Safety Concerns With Proposed Grade 7-12 School At 20 Woolner Trail

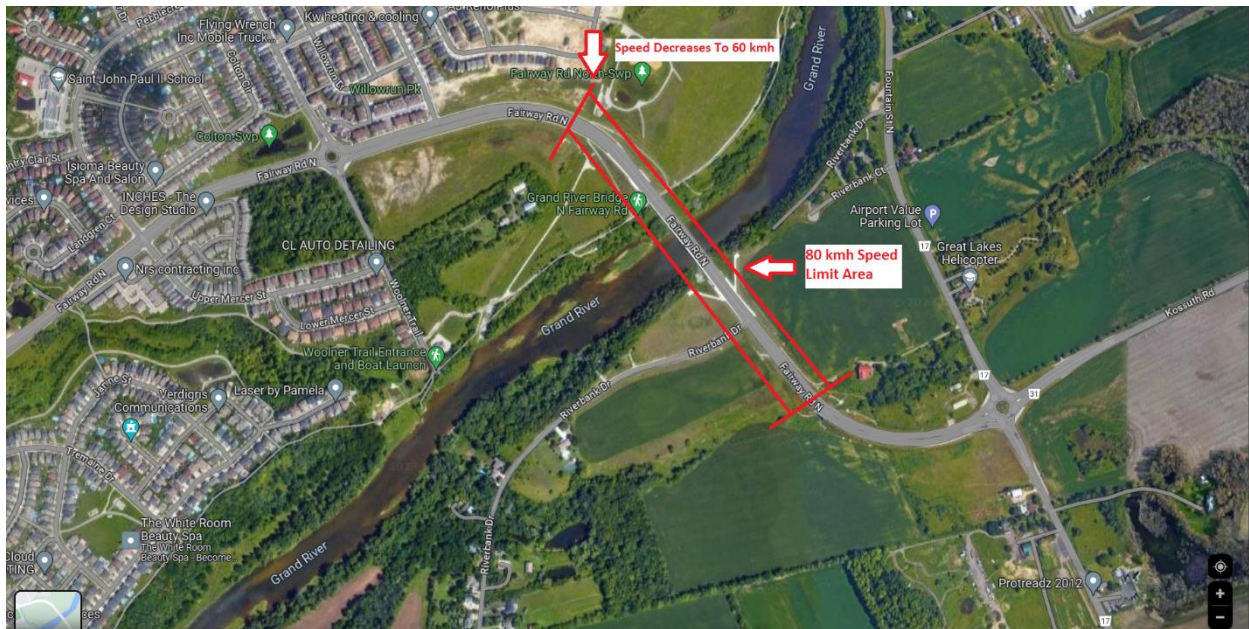
Coming out of the Fairway Road/Fountain Roundabout the speed limit on Fairway Rd North increases to 80kmh. The image below shows the approximate 700 metre 80kmh area and where it decreases to 60.

This is close to Eden Oak Trail and the school property. Drivers don't always slow down right where the 60kmh sign is located. It is also close to the Roundabout where students will be crossing.

A Community Safety Zone is an option for the Region of Waterloo to implement. Could one be established from Upper Mercer Drive to Eden Oak Drive?

Could the St. Mary's model be replicated here with the speed coming from the Fairway and Fountain Roundabout reduced to 70, with a reduction to 50kmh where the current 60kmh limit begins and a 30kmh at the Roundabout established.

Could a 50kmh limit also be in place right through to, and past Fairway and Lackner to mutually benefit Chicopee Hills School and create a safer zone around and between these 2 schools?

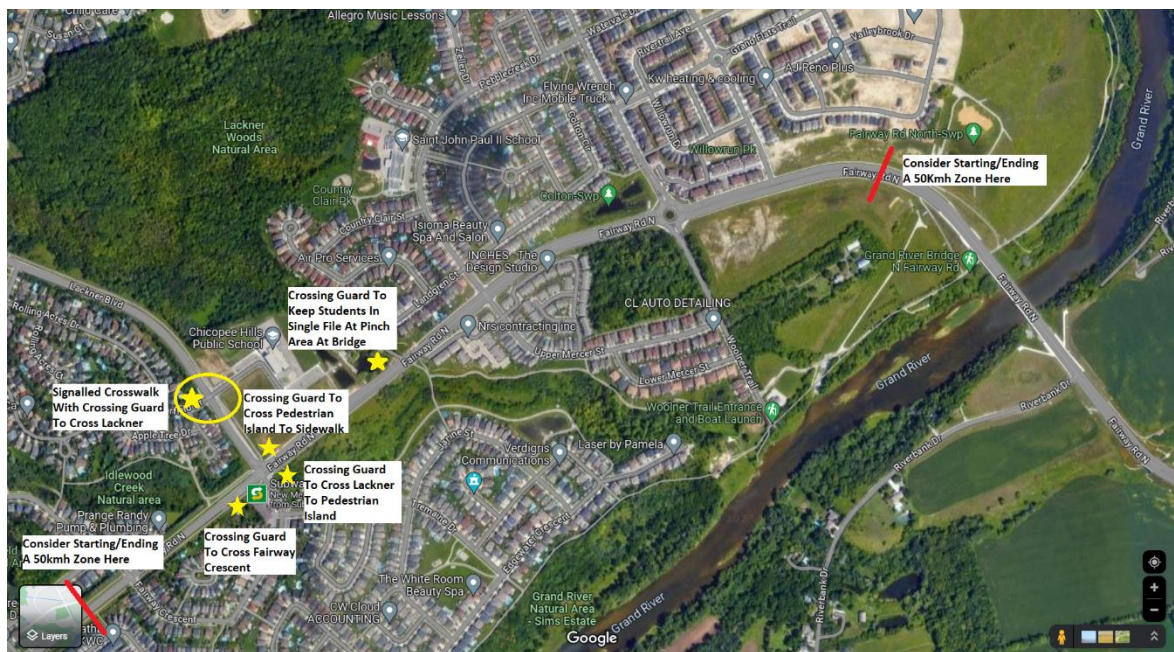
This image below shows the crossing guard locations for Chicopee Hills School and the signalled crosswalk at Lackner and Corfield. The Fairway/Lackner intersection has traffic lights. It also shows a potential 50kmh zone to benefit this new school and Chicopee Hills School.

5 crossing guards are used for student safety at this JK to Grade 8 school. This new school proposed at 20 Woolner Trail will be a Grade 7 to 12 school. Crossing will be done at a Roundabout area.
